IOWA DEPARTMENT OF TRANSPORTATION

TO OFFICE: District 6
DATE: April 27, 2017
ATTENTION: Jim Schnoebelen
REF. : Dubuque County
FROM: Kevin K. Patel
STP-052-2(119)--2C-31
PIN: 10-31-052-020-02
OFFICE: Design
SUBJECT: Field Exam (D2)

PLANS OF PROPOSED IMPROVEMENT ON THE

From Approx. 0.7 Mile N. Of Boy Scout Rd. N. To E. Jct. Pfeiler Rd.

E St. Joseph's Drive Intersection

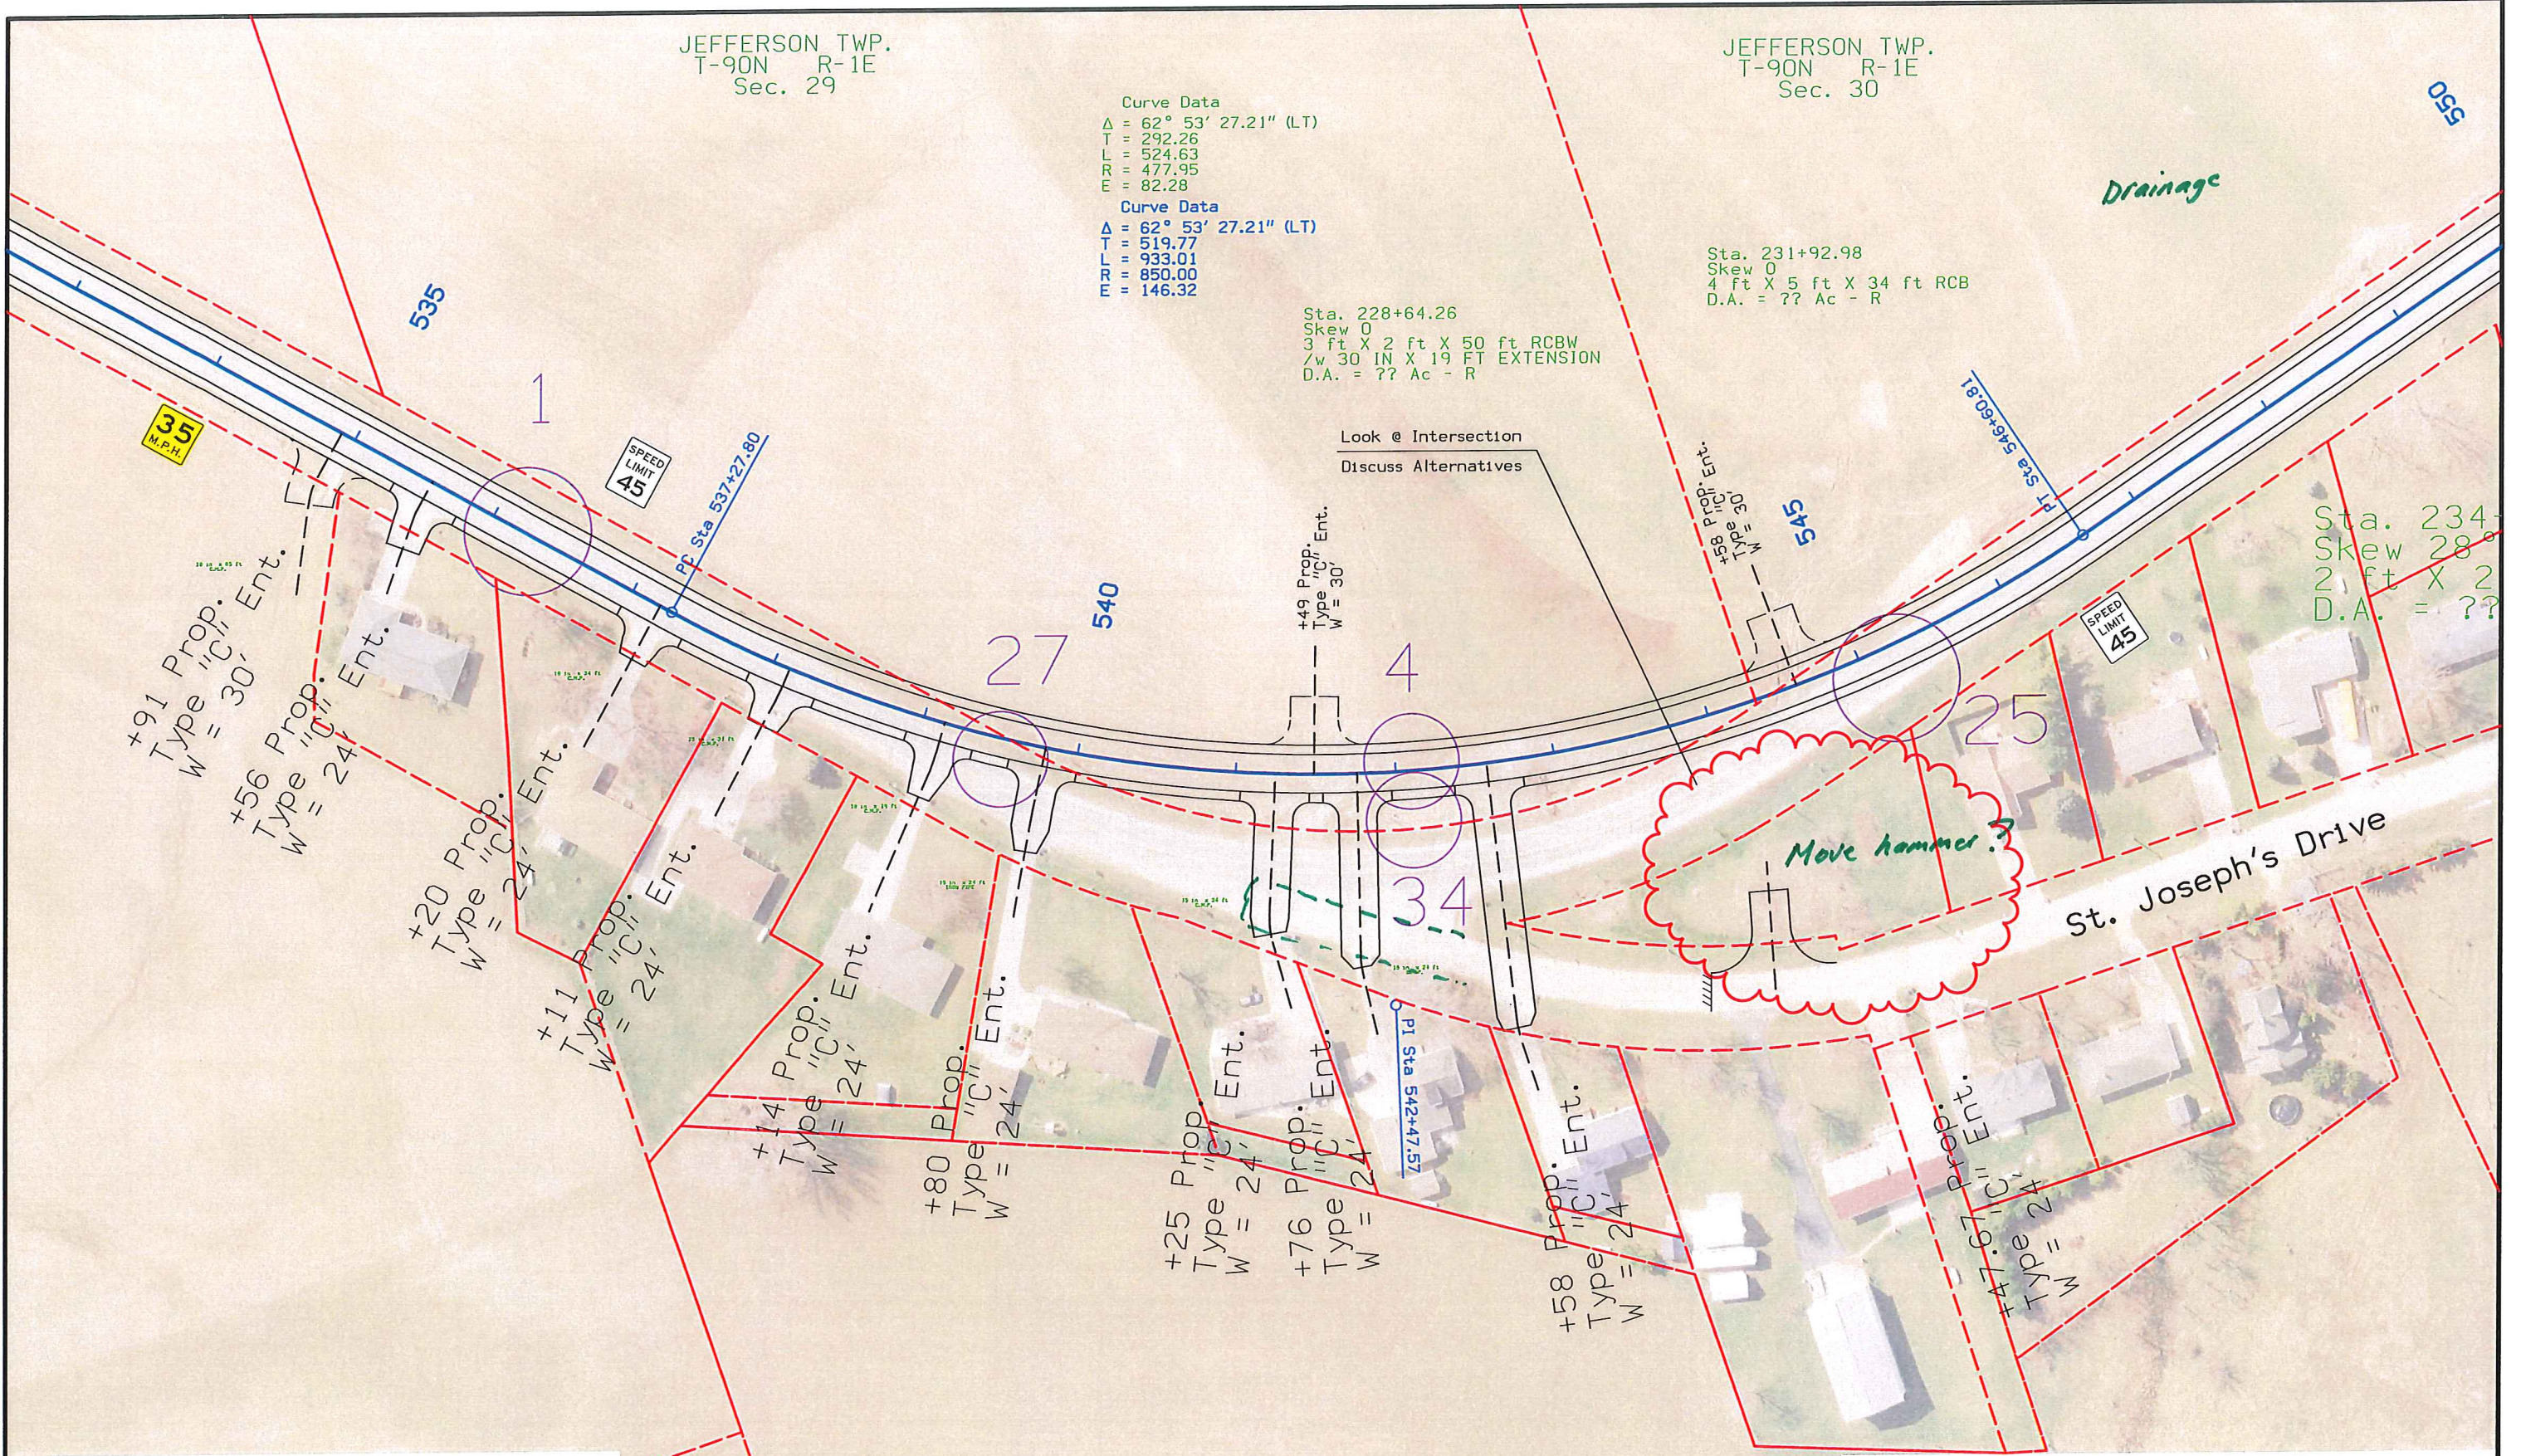
The existing St. Joseph Drive intersection with U.S. 52 results in an acute skew angle which is undesirable. Therefore, it was recommended that St. Joseph's Drive be terminated prior to the intersection and a hammer head turn around be constructed. In addition to this the mainline horizontal curve near St. Joseph's Drive will be flattened and shifted to the south which will result in some residential properties having longer driveways. This design will be reviewed with the City of Rickardsville to get their input. The north ditch of St. Joseph's Drive does not appear to drain well and should be reviewed for installation of cross road culvert.

- 6) Discuss entrances just east of cemetery at Sta. 495+00.
- 7) St. Joseph's Drive East intersection – Discuss options:
 - Option 1: Close connection & provide hammerhead – Reroute local traffic west to James Road.

- Option 2: Keep east intersection open, but shift intersection to the west.
- 8) Discuss drainage options in north ditch along Rickardsville hill.
- 9) Discuss foreslope & impacts to ~~west~~ *South* of US 52 along Rickardsville hill.
